APPENDIX I QRA PEER REVIEW KAPUNI J WELLSITE – ENVIRONMENTAL RISK SOLUTIONS

TODD ENERGY LTD KAPUNI J WELLSITE QRA REVIEW

DOCUMENT NO. : J92247CTR12

DATE 16 April 2019

Figure 7-1 Parts count undertaken for comparison with WorleyParson values

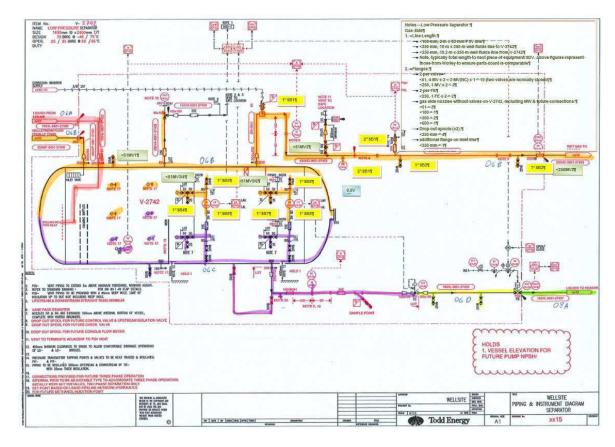
Table 7-1 provides the difference in the parts count, with significant differences attributable in part due to the rule sets that may or may not have been used. WorleyParsons' assumptions for the parts count are not fully transparent and assumptions used by Environmental Risk Solutions (ERS) as a cross check included:

- HCRD states "Includes small-bore connections for flow, pressure and temperature sensing. The scope includes the instrument itself plus up to two valves, four flanges, one fitting and associated small-bore piping, usually 25 mm diameter or less."
- normally closed valves are assumed to isolate the fluids and any equipment downstream of the valve is not included in the parts count, i.e. typically such an arrangement would include one valve and one flange.

The impact of differences in parts count may be significant. **Table 7-2** shows that the estimated frequency for hole sizes in the range of >150 mm is approximately 14% higher (2.36E-4 vs 2.07E-4). This variation reflects the need to ensure an accurate as possible parts count, and also that there are limits to the overall confidence level for a QRA depending on the analyst.

Consideration should be given to providing a 'rule-set' to be used for the parts count.

Develop a QRA methodology and include in that methodology, a requirement for 'rule-sets' to enable transparency of how the parts were counted.

Figure 7-3 Ratio of frequencies – DNV data to Netherlands tabulation (Ref. 7 'Failure Frequency Guidance, Process Equipment Leak Frequency Data for Use in QRA')

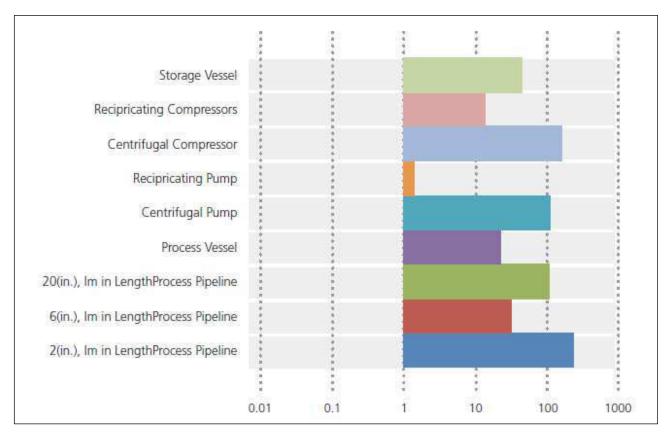
DNV (Ref. 7) highlight the significant differences in alternate sources of leak frequency data which is shown in **Figure 7-3** with reference to Dutch data sources. **Figure 7-3** shows that the HCRD values are more than 100 times higher than the Dutch government.

Include in the QRA, a section on the confidence level that may be given to the numerical/calculated results with the caveats that the QRA is considered to have been undertaken to best industry practice, however, due to limitations on confidence levels associated with QRA inputs and calculation methodologies, the overall calculated values have a relatively low confidence level and should be used for guidance in decision-making as opposed to being a decision maker and that despite a low confidence limit, the results may be used to identify risk drivers.
